# KAUAI

## WAINIHA BRIDGES PROJECT, KŪHIŌ HIGHWAY, ROUTE 560

The purpose of this memorandum is to clarify the Intent of the Wainiha Bridges Project, provide additional information regarding design criteria, and provide an update of the Wainiha Bridges design in light of the public comments received. As identified in the Draft EA, the primary purpose of the project is to replace the three temporary Wainiha bridges (referred to as Wainiha Bridges 1, 2, and 3) to maintain continued access along Kūhiō Highway. Additional issues (secondary project purposes) have been identified through engineering evaluation and agency and public outreach. These include the following:

**Figure 4. Acrow Bridge 1 – 14 feet wide travel way**

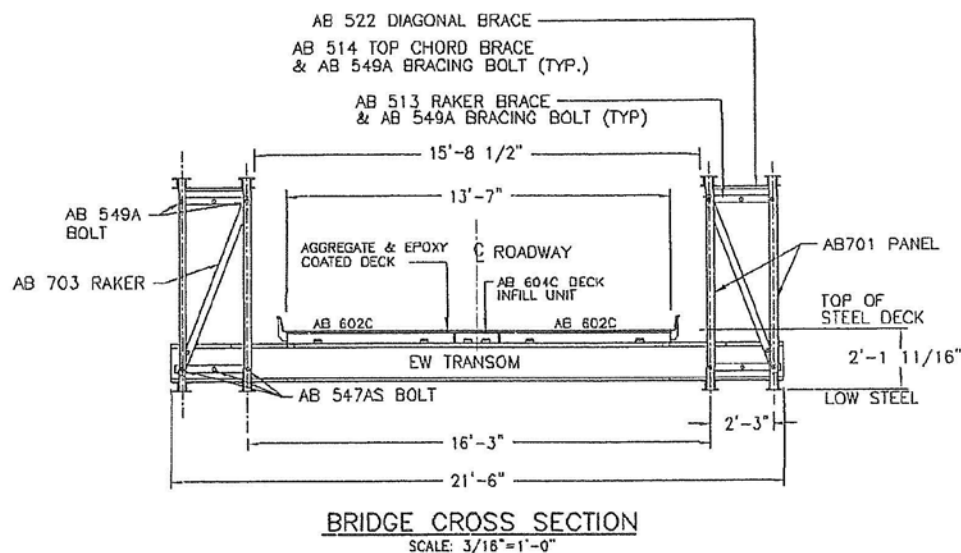
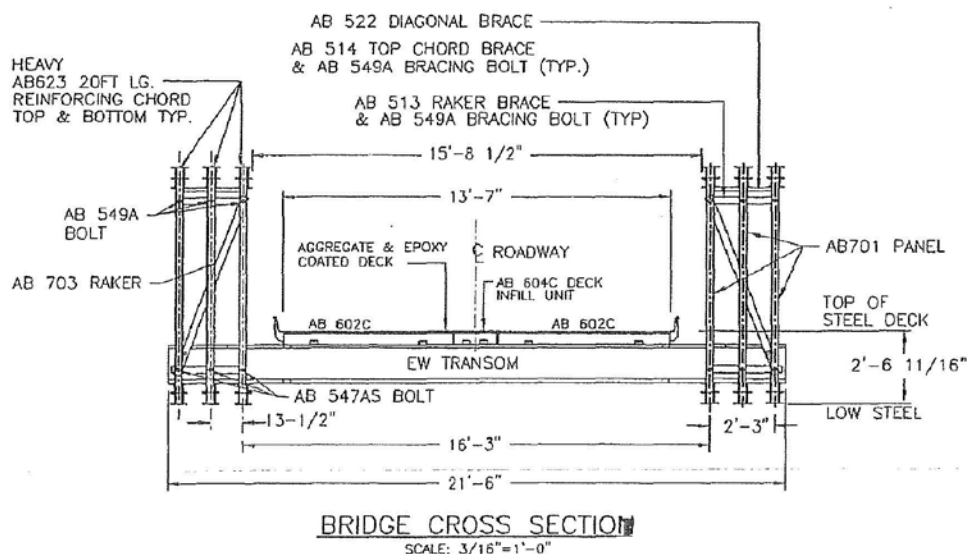
*The Hawaii Department of Transportation has decided to replace the three bridges in Wainiha. Currently these three bridges are **11 feet wide**. The HDOT proposes to increase the width of these three bridges to **14 feet wide**. This is unacceptable for the following reasons: If we allow HDOT to make the 3 Wainiha bridges 14 feet wide it will allow tour buses to access our beaches and parks in Haena and Kee. This will forever change the peaceful tranquility and country feel of this area. It will allow massive development in Kee. It will change the area from rural use to a tourist Mecca . We are strongly opposed to widening the 3 bridges. We want them kept as is. If the bridges need to be upgraded for safety, we ask that the community's wishes be obeyed, and the historical nature of the 3 bridges remain. The community wants 11 foot wide bridges.*

Unfortunately, this petition did not provide a clear comparison of the existing Acrow bridge widths versus the proposed bridge widths. For the last nine years (Since the 2007 replacement) the Wainiha Acrow Bridges have accommodated a 12-foot minimum (Bridge 2), single-lane bridge roadway typical section (Figure 5). Additionally, the temporary Acrow Wainiha Bridges 1 and 3 currently have a 13-foot 7-inch

single-lane bridge typical section as identified in Figures 4 and 6. The proposed action as presented within the Draft EA would make the bridge widths uniform for all three bridges at 14-feet.

Figure 8. Proposed Typical Section from Draft April 2016 EA (Figure 2-1).

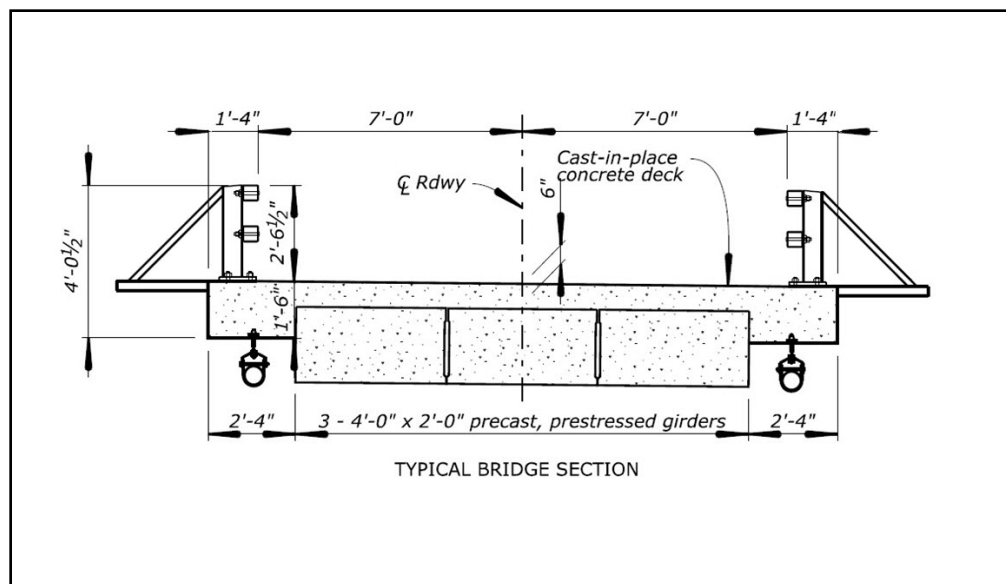
On April 23, 2016 the Draft EA was released for public comment. The Draft EA presented a proposed bridge design for three permanent one-lane bridges with a 14-foot roadway section from rail to rail, with an additional 1-½ feet on each side to support bridge rails and for hanging utilities. During the public comment period 15 agency and public comments were received and petition entitled The "Petition to Stop the Wainiha Bridge Project" was circulated by concerned citizens. One hundred and twenty three signatures were obtained as part of the Wainiha Petition. The Petition read as follows:

Figure 9. Modified Proposed Typical Section with Timber Deck.

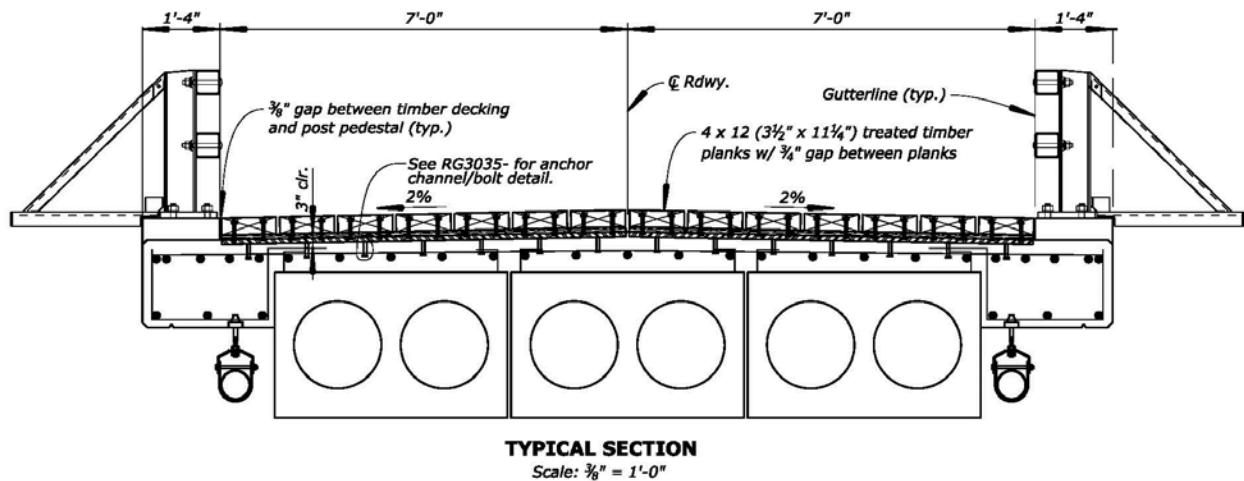
Additionally, the 1957 Wainiha bridges contained several key design elements that were to be considered as aesthetic treatments for the replacement Wainiha Bridges. These elements included the decking material, pedestrian and vehicle railing, and end treatments. The 2012 HDOT EDR stated that bridge decking will be designed to mimic the placement of the timber planking on the previous bridges. Replacement design will incorporate timber or timber facsimile for the traveled way surface. The public has commented numerous

times on wanting to replicate the unique look, feel and sound of the historic Wainiha bridges. It is well documented that in a wet environment such as that found at the Wainiha Bridges, timber planks experience increased wear and/or rot. This results in a need for replacement periodically, which adds considerably to HDOT's maintenance workload and material costs as well as major traffic stoppages during such repairs. Additionally, the CFLHD has also received design recommendations from the National Marine Fisheries Service (NMFS) on other similar bridges near the Kauai coast. The NMFS has recommended that CFLHD avoid the use of metal (e.g. copper) and pressure treated lumber (e.g. creosote) and further ensure that materials used for the bridge or retaining walls are nontoxic to aquatic organisms. Copper leaches from metal treated wood while polycyclic aromatic hydrocarbons leach from wood treated with creosote. Avoiding the use of these types of treated wood products would avoid or minimize potential adverse effects to human and fish health within adjacent aquatic habitats. As presented in the April 23, 2016 draft EA, the FHWA-CFLHD initially proposed a cast in place concrete bridge deck that was treated with a timber-like appearance. This design was intended to provide a timber facsimile (through color and surface application and treatment) for aesthetic purposes while reducing maintenance costs and addressing aquatic resource concerns raised by the NMFS. However, following the public comments that support a bridge design that replicates the timber deck of the 1957 Wainiha Bridges; the CFLHD has spent the last few months redesigning the Wainiha bridge to include a true timber deck. The proposed Wainiha Bridges now include a timber deck made from 4 inch by 12 inch treated lumber installed longitudinally as was present on the 1957 historic Wainiha bridges (See Figure 10). This design revision is presented in figures 9 through 12 below. The EA is being updated to present the modified bridge deck design.

Additionally, it was documented within the 2012 HDOT EDR that all replacement Wainiha bridges will utilize vehicular and pedestrian compliant railings. The 1957 bridge railings consisted of a simple 2x4 lumber design. It was assumed in the EDR that the proposed rails could use Structural Steel Tube (SST) Railings for the replacement bridges that comply with Test Level 2 (TL-2) of the AASHTO standards while mimicking the aesthetics of the 1957 bridges. Railing picket spacing was also discussed as a desire to mimic the original 1957 Bridge railing spacing has been expressed by the local community. During design development, the FHWA-CFLHD elected to utilize the SST railing as recommended within the 2012 HDOT EDR report to restore the visual aesthetic of the historic 1957 Wainiha bridges rails while ensuring rail crashworthiness and maintenance objectives are met for the replacement structures. As is shown in Figures 9 through 12, the proposed SST railing is aesthetically similar to the 1957 bridges, while meeting current crashworthiness standards. The SST has similar rail picket spacing and is slightly shorter than the 1957 railings to improve sight distance on the bridges.
